UNRESOLVED ISSUES REPORT

January 3, 2014

ICC/ANSI A117.1 STANDARD DEVELOPMENT - 2014 EDITION

FIG. 607.2(b)
CLEARANCE FOR BATHTUBS

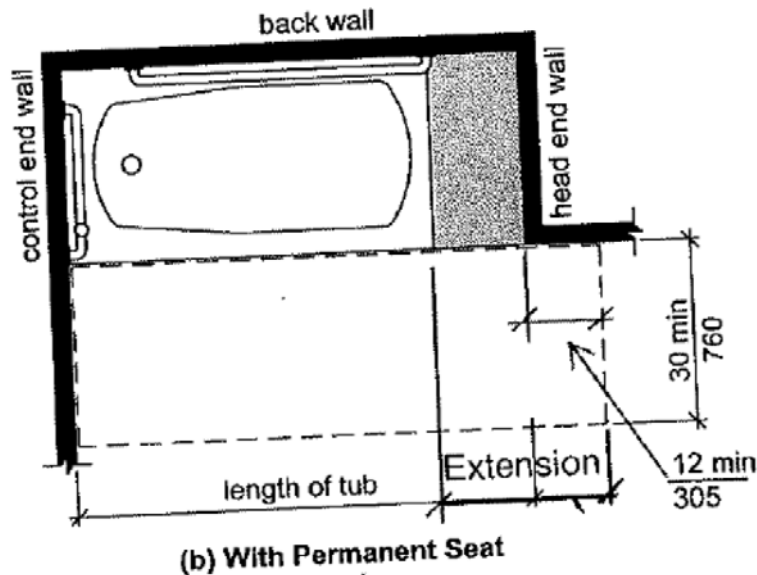
Reason: The current Figure 607.2 is not literally consistent with the text. If the diagram can be revised by the editorial committee to be consistent with the current text, I would consider my comment resolved.

The length of the tub is not the tub and the seat as indicated in Figure 607.2(b). The overall dimension is correct.

Section 607.4.1 sets the 'depth' of the seat. The current language skips the piece between the 'length of the tub' and the end of the extension. This is a technical issue that just gives you all the pieces. Please see graphic revision attached.

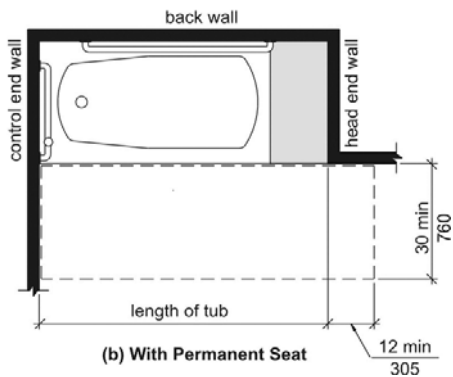
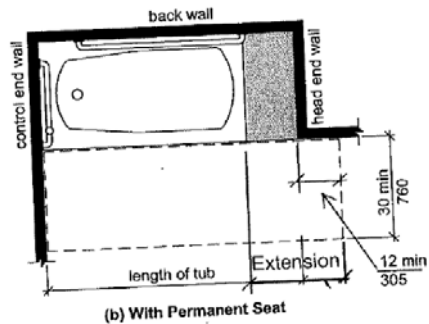
Comment: The language needs to match Figure 607.2(b). The current text has a gap between the end of the tub and the space past the end wall.

Comment: The permanent seat and extra 12" beyond needs better description.

Reason: The committee said the current language was clear, however, I sincerely believe they were looking at my corrected drawing, and not the existing Figure 607.2(b). See below. Definitely what is shown is not the length of the tub. If the language is clear, the drawing should be corrected – or both.

Committee Reason: The committee considered the information provided by the comments and decided to take no action to change its original disapproval of this proposal. The committee concluded that the existing text is sufficiently clear and does not need to repeat the depth of the seat measurement. The clear floor space is measured from the wall regardless if there is a building in seat or not.

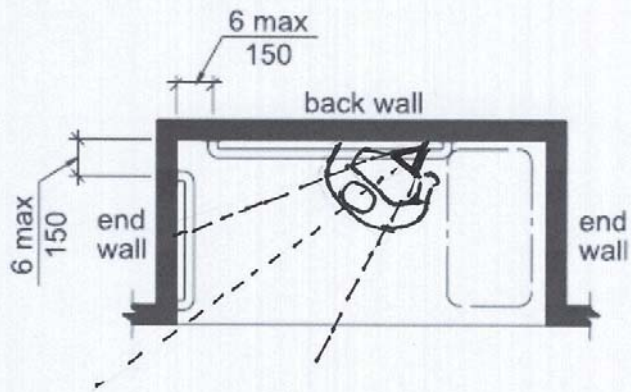
608.3.2 Standard Roll-in Type Showers. Grab bar for standard roll-in showers shall comply with Section 608.3.2. In standard roll-in type showers, grab bars shall be provided

608.3.2.1 Horizontal Grab Bars. Horizontal grab bars shall be provided on the back wall beginning at the edge of the seat. The grab bars shall not be located above the seat. The back wall grab bar shall extend the length of the wall but shall not be required to exceed 48 inches (1220 mm) in length. Where a side wall is provided opposite the sea within 72 inches (1830 mm) of the seat wall, a grab bar shall be provided on the side wall opposite the seat. The side wall grab bar shall extend the length of the wall but

shall not be required to exceed 30 inches (760 mm) in length. Grab bars shall be 6 inches (150 mm) maximum from the adjacent wall.

608.3.2.1.1 Vertical Grab Bar. Where an ambulatory roll-in shower control and hand spray are provided, a vertical grab bar shall be provided. A vertical grab bar 18 inches (45 mm) minimum in length shall be provided on the ambulatory control side wall 3 inches (75 mm) minimum and 6 inches (150 mm) maximum above the horizontal grab bar, and 4 inches (100 mm) maximum inward from the front edge of the shower.

Existing ANSI 608 Standard Roll-in Shower

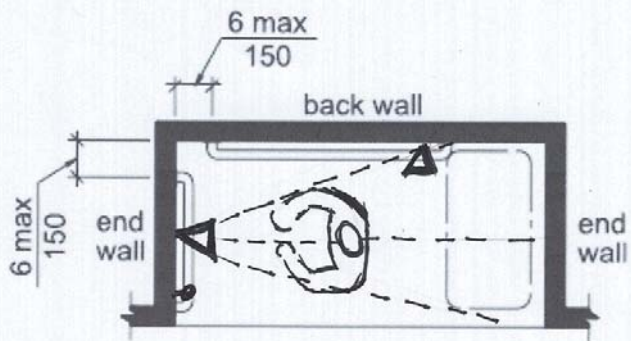
- Half the spray goes out into the room.
- Person must stand as close as possible to spray and their elbows hit the back wall
